Report FL #: 10088 for Greenheck models EHH-601D & ESD-635D (both w/ and w/o VCD-40 Damper)

Report FL #: 10093 for Airolite models SCH601MD & K6746MD (both w/ and w/o VCD-40 Damper)

APPROVAL DOCUMENT: Drawing No. **K6746MD**, titled "K6746MD Louver", sheets 1 through 37 of 37, dated 08/09/2017, prepared by The Airolite Company, signed and sealed by Wayne K. Helmila, P.E. on 08/19/2024 and 09/27/2024, bearing the Miami-Dade County Product Control revision stamp with the Notice of Acceptance number and expiration date by the Miami-Dade County Product Control Section.

PRODUCT REVISED
as complying with the Florida
Building Code
NOA-No. **24-0930.05**
Expiration Date **12/06/2029**

TITLE
K6746MD LOUVER W/VCD-40
CONTINUOUS ANGLE MOUNT
JAMB DETAILS
H $\leq$ 144"

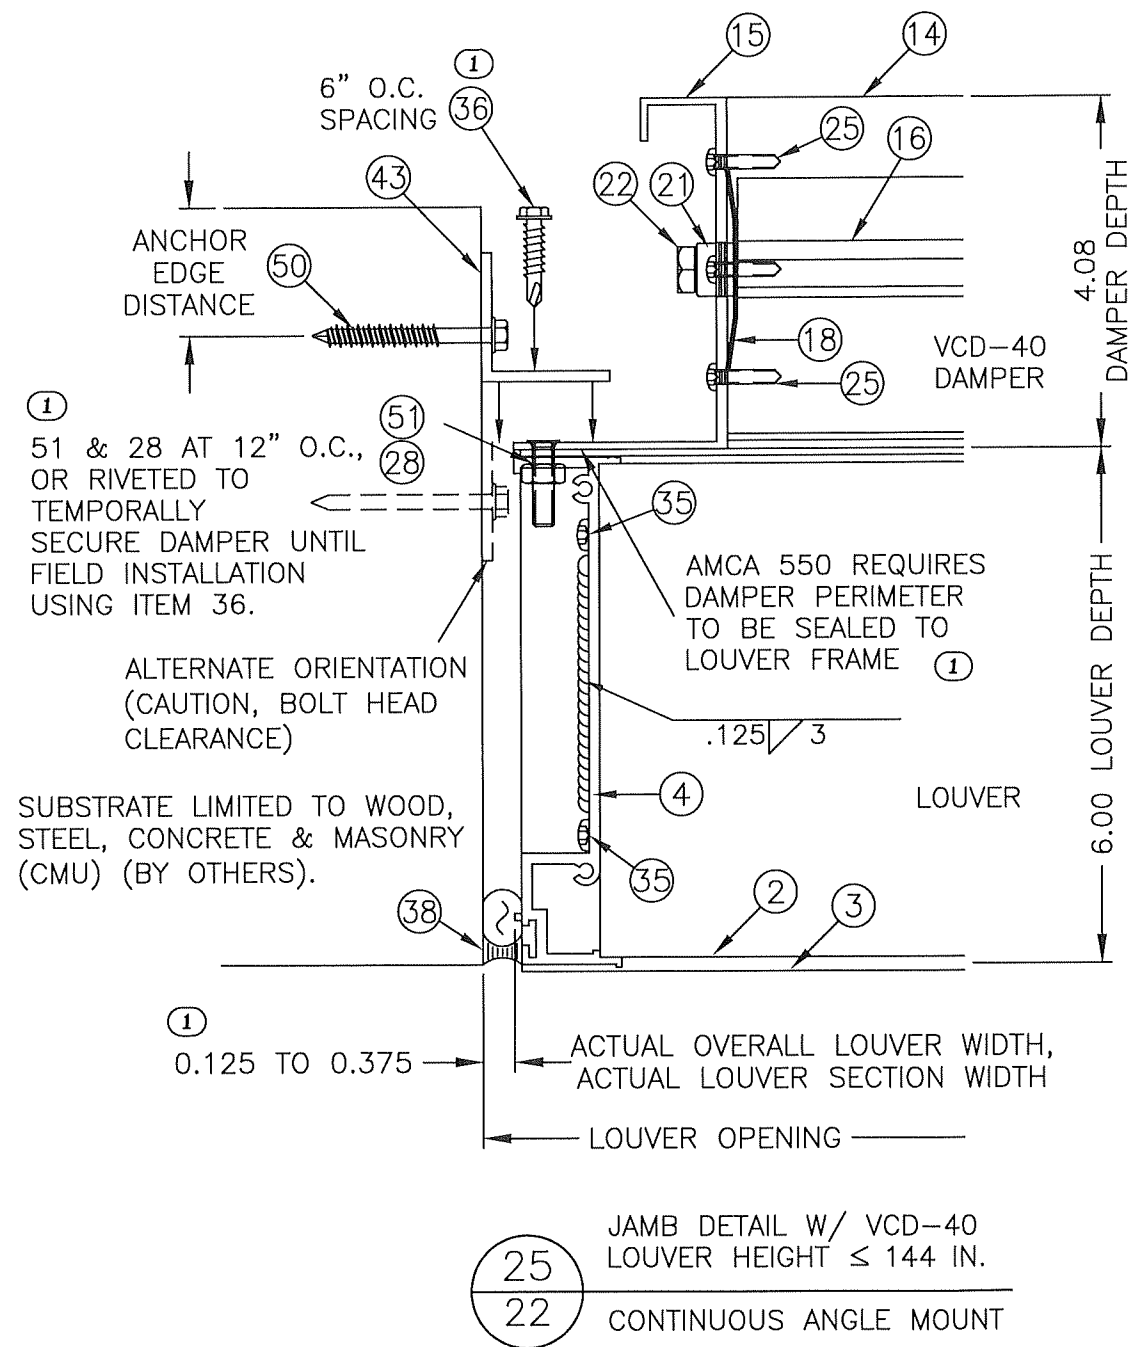
REV 01: 8/1/24, WAS PAGE 17, MOVED DETAILS 26A&B TO A NEW PAGE, UPDATED ON CENTER, REPLACED ITEM 37 WITH ITEM 36, ADDED DAMPER RIVET ATTACHMENT NOTE, REMOVED "TYP" FROM EDGE GAP, & ADDED AMCA 550 NOTE.

DRAWN BY MES		DATE 8/9/2017
SCALE		
SHEET NO. 23 OF 37		
CAD DRAWING NO. K6746MD		
 SCHOFIELD, WISCONSIN 54476 715-359-6171 TITLE K6746MD LOUVER W/VCD-40 CONTINUOUS ANGLE MOUNT MULLION DETAILS H≤144" & H≤96"

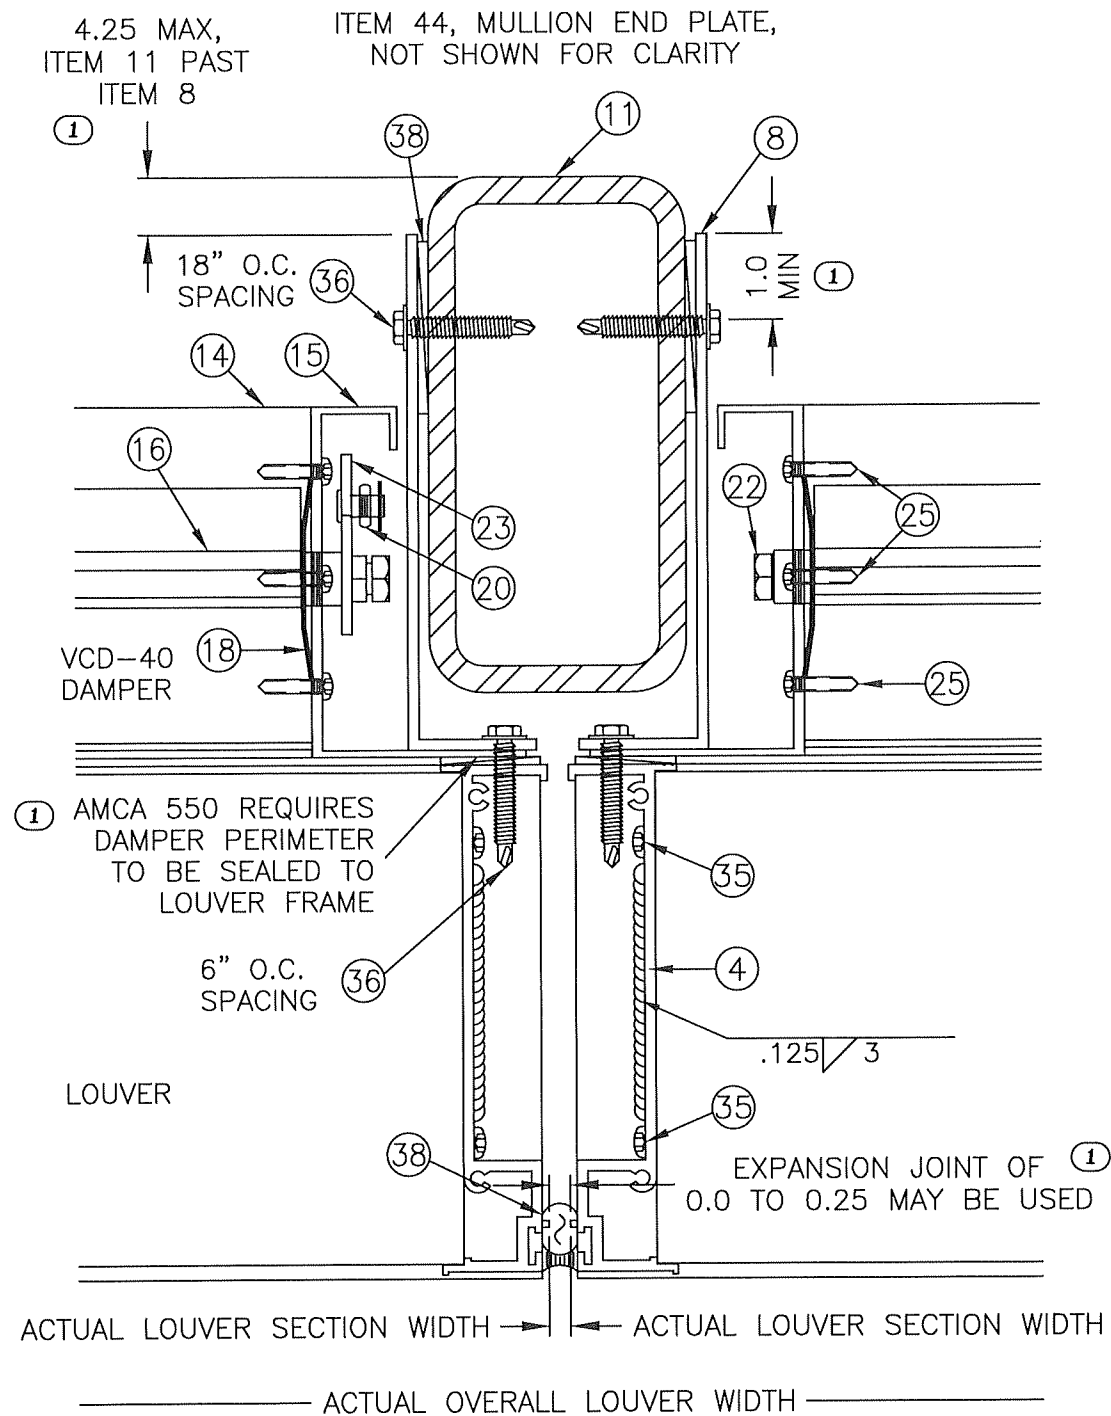
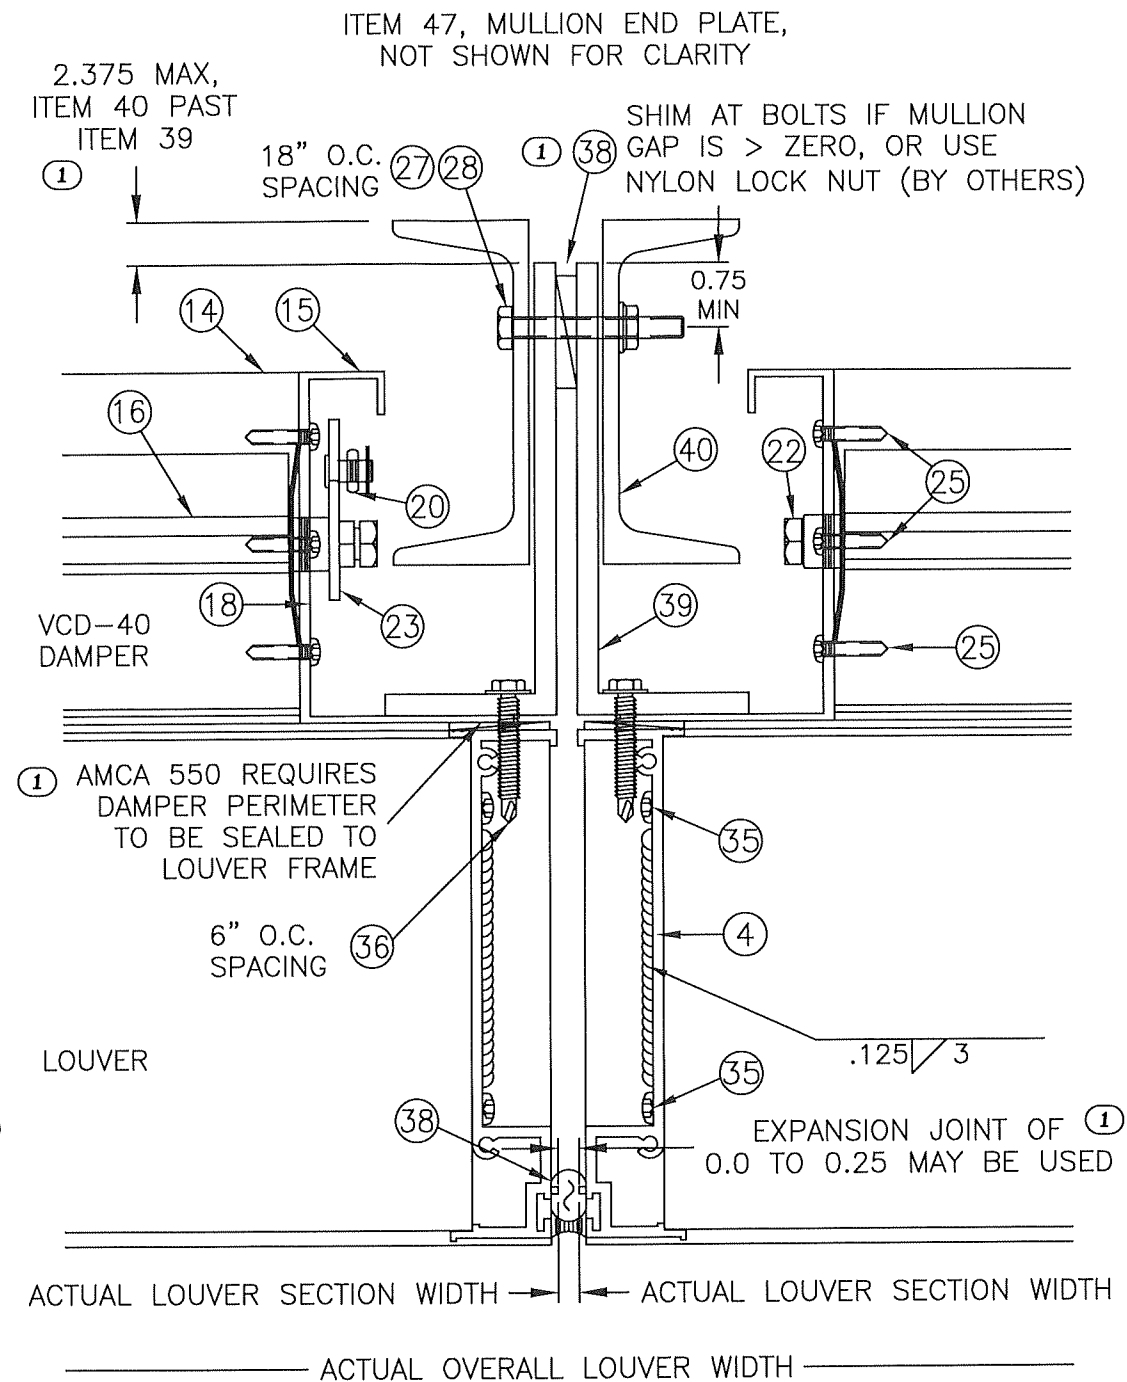
REV 01: 8/1/24, MOVED DETAIL 26A&B TO THIS NEW PAGE,
REDEFINED ITEM 11 & 40 MAX OFFSETS, ADDED 1.0 & 0.75
MIN OFFSETS, REWORDED MULLION GAP NOTE X2, ADDED
ITEM 38 & NOTE, & ADDED AMCA 550 NOTE X2.

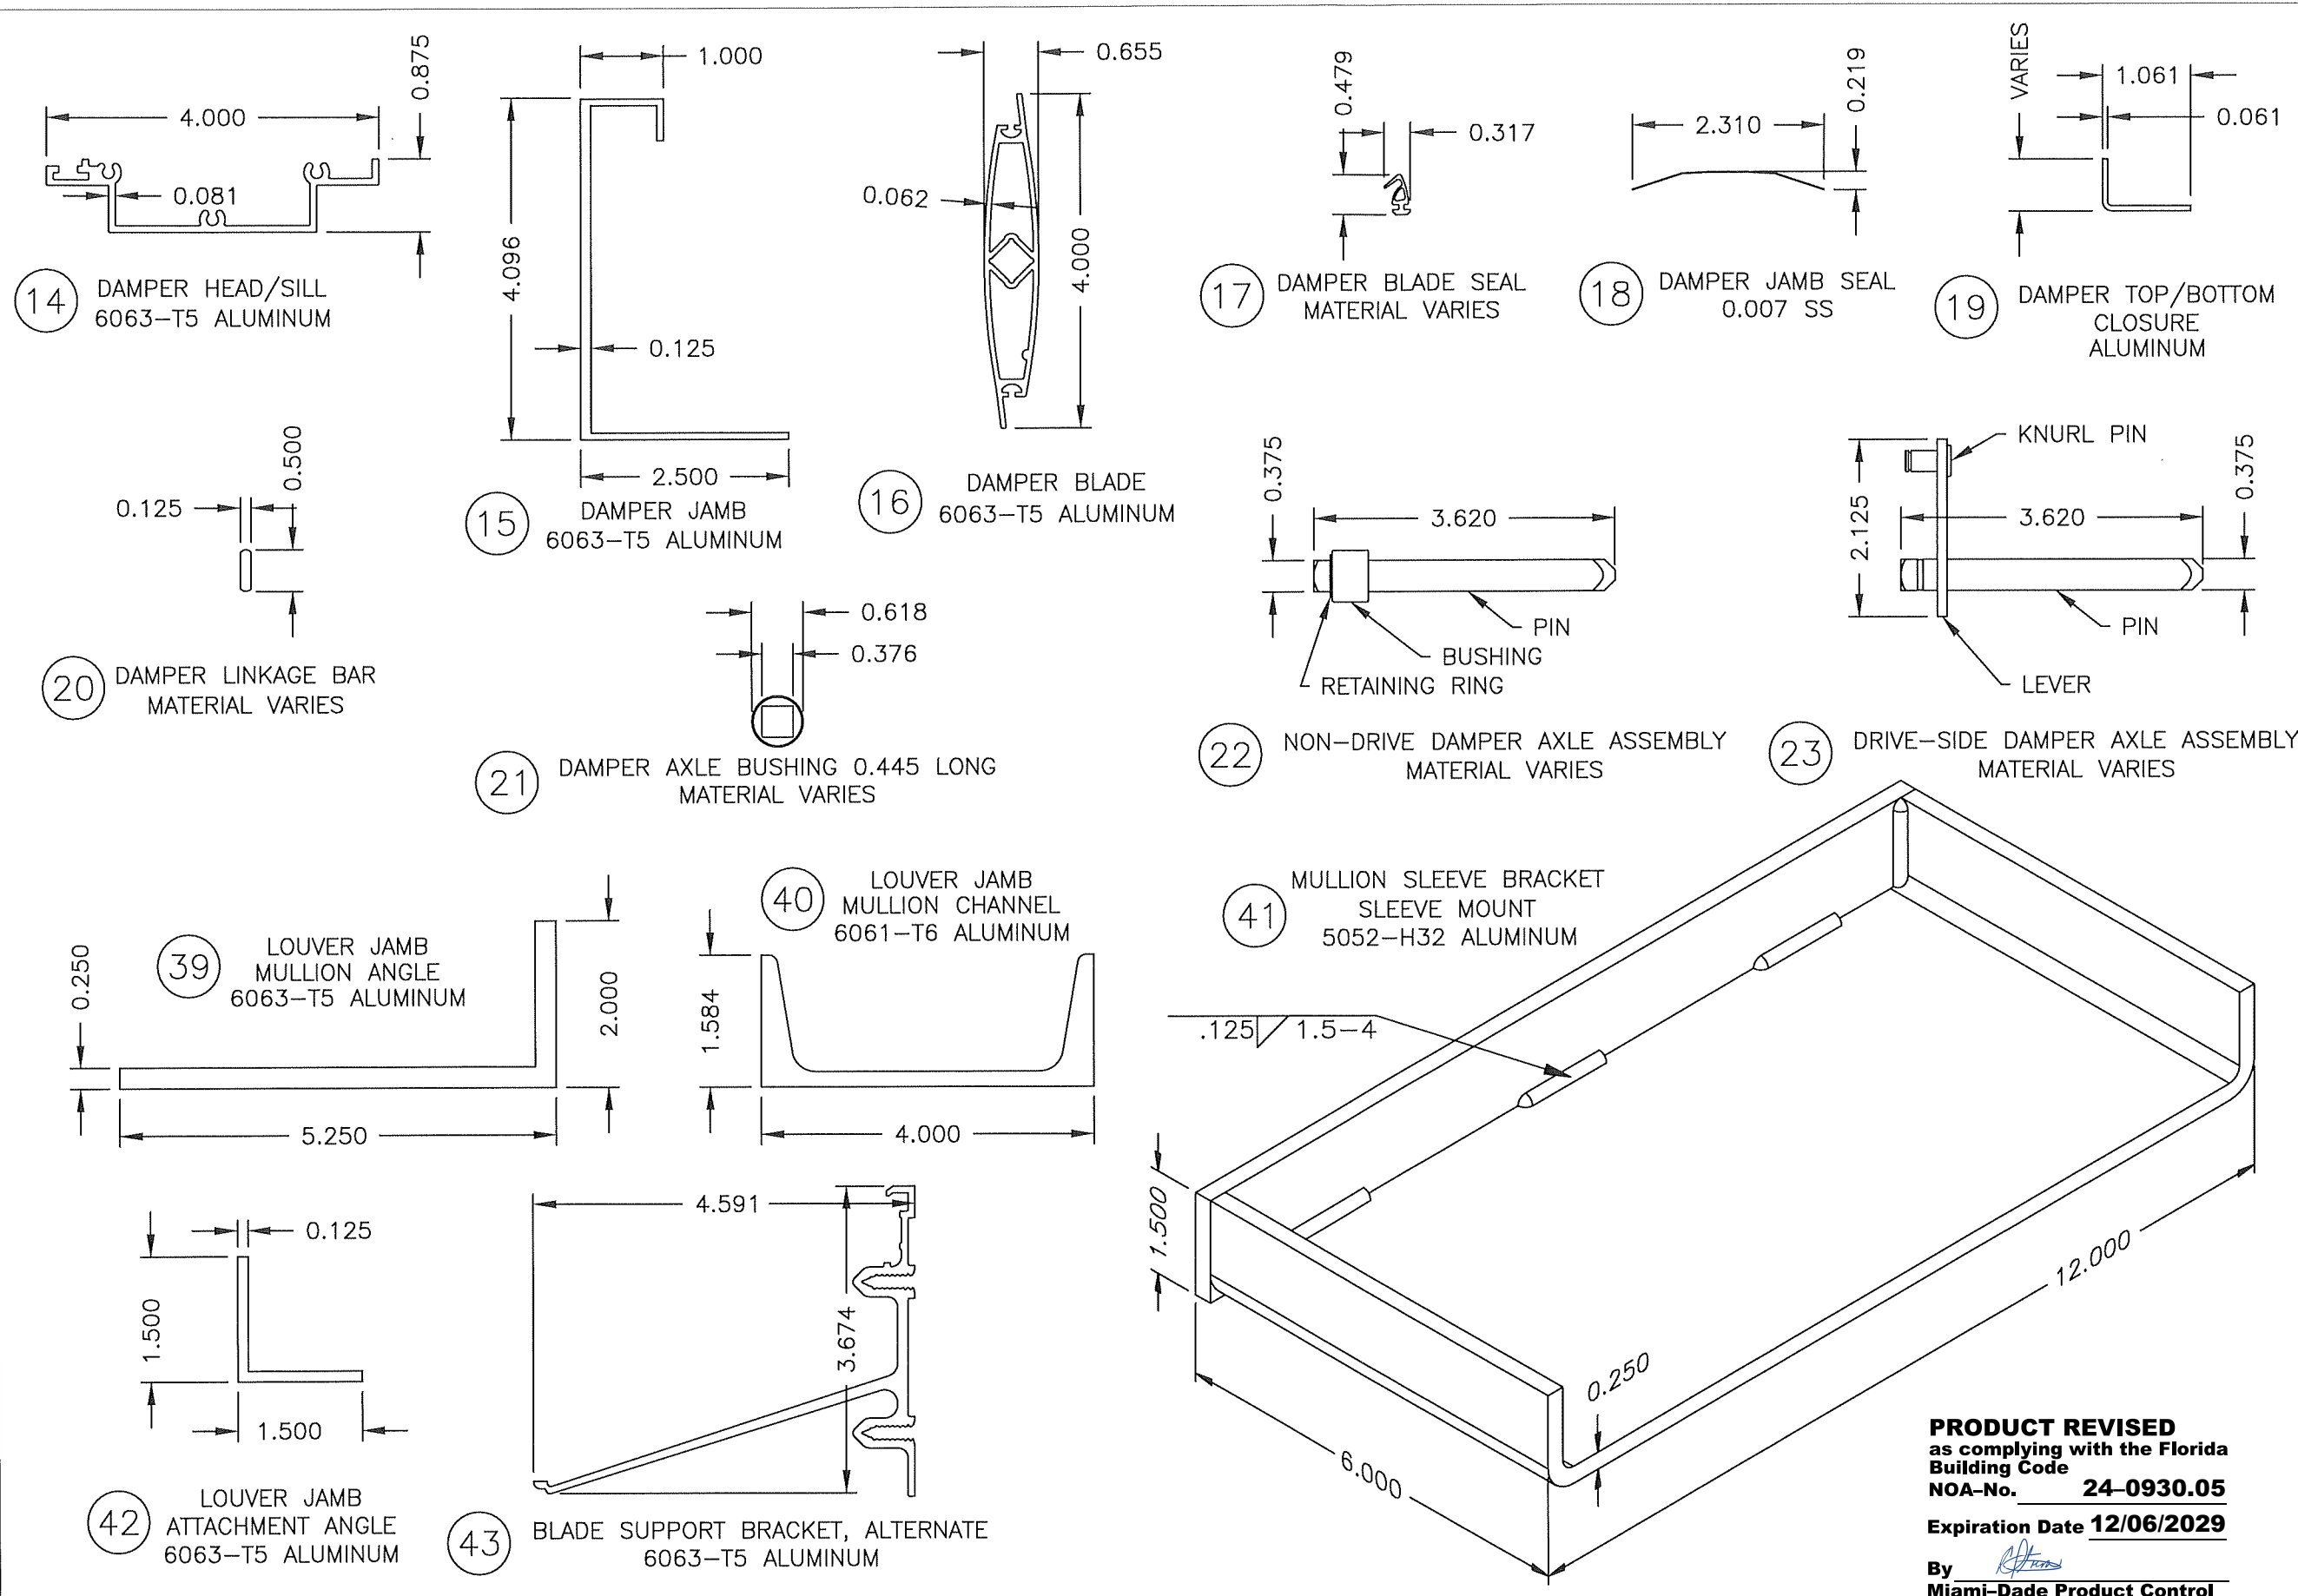
REV 01: 8/1/24, WAS PAGE 20, ADDED HEIGHTS FOR ITEMS 2A & 2B, ADDED NOTE AND BOSSES TO ITEM 3, UPDATED ALLOY OF ITEM 8, & CORRECTED LENGTH OF ITEM 10.

AIROLITE SCHOFIELD, WISCONSIN 54476 715-359-6171	DRAWN BY MES	DATE 8/9/2017
	SCALE	
TITLE K6746MD LOUVER CONTINUOUS ANGLE MOUNT MULLION ANGLE, STEEL/WOOD PART PROFILES		SHEET NO. 29 OF 37
		CAD DRAWING NO. K6746MD

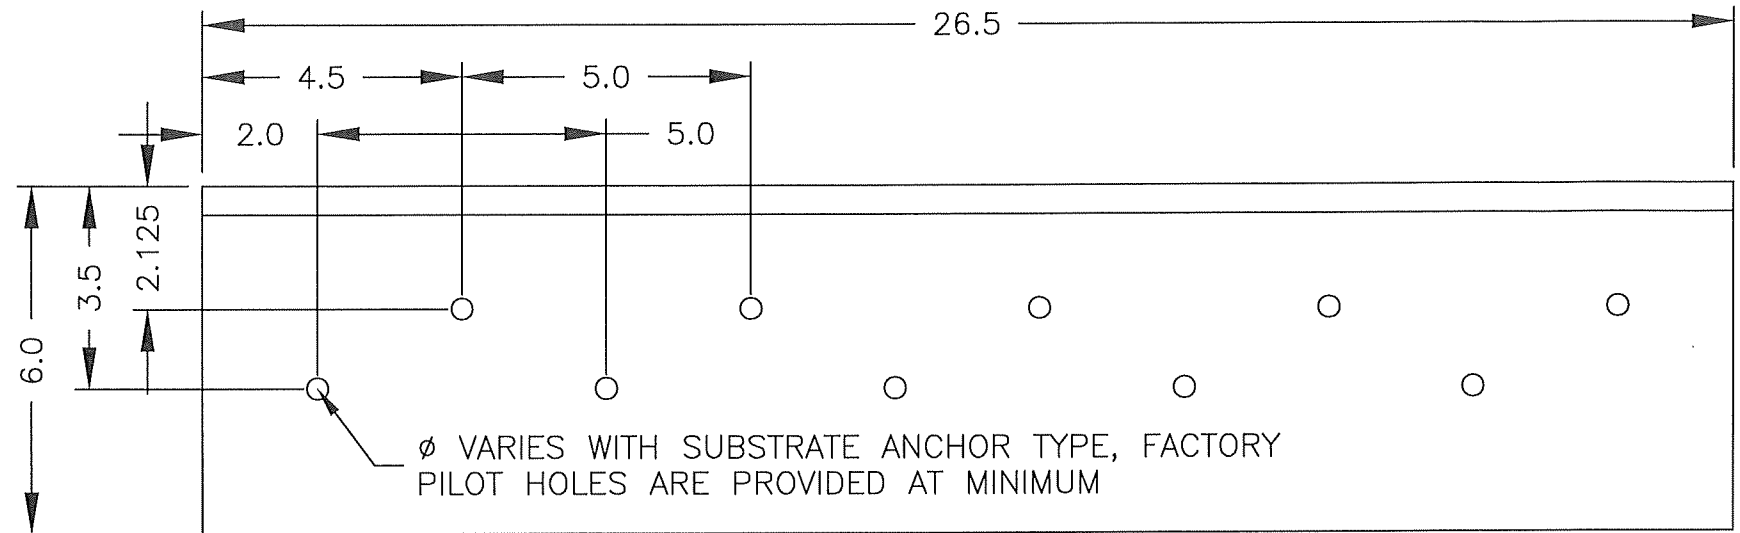
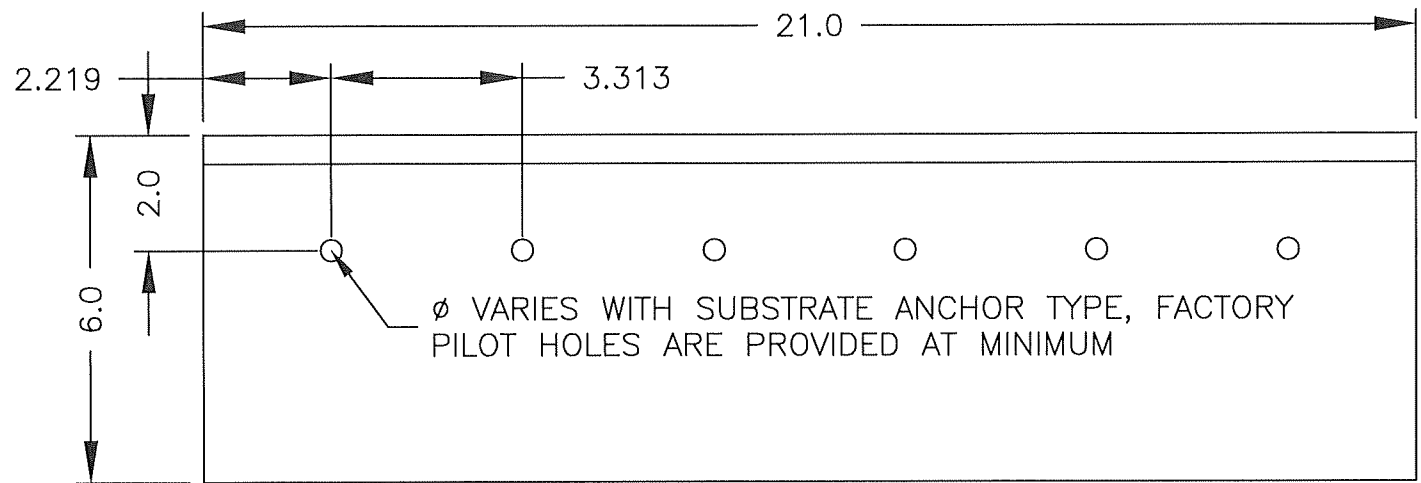
REV 01: 8/1/24, MOVED ITEM 48 TO THIS NEW PAGE & SPLIT IT INTO SIX
ITEMS WITH 48A1/B1 ON THIS PAGE & ITEMS 48A2/B2 & 48A3/B3 ON
ANOTHER NEW PAGE, UPDATED HOLE PATTERNS & LENGTH OF ITEMS 48A1/B1.
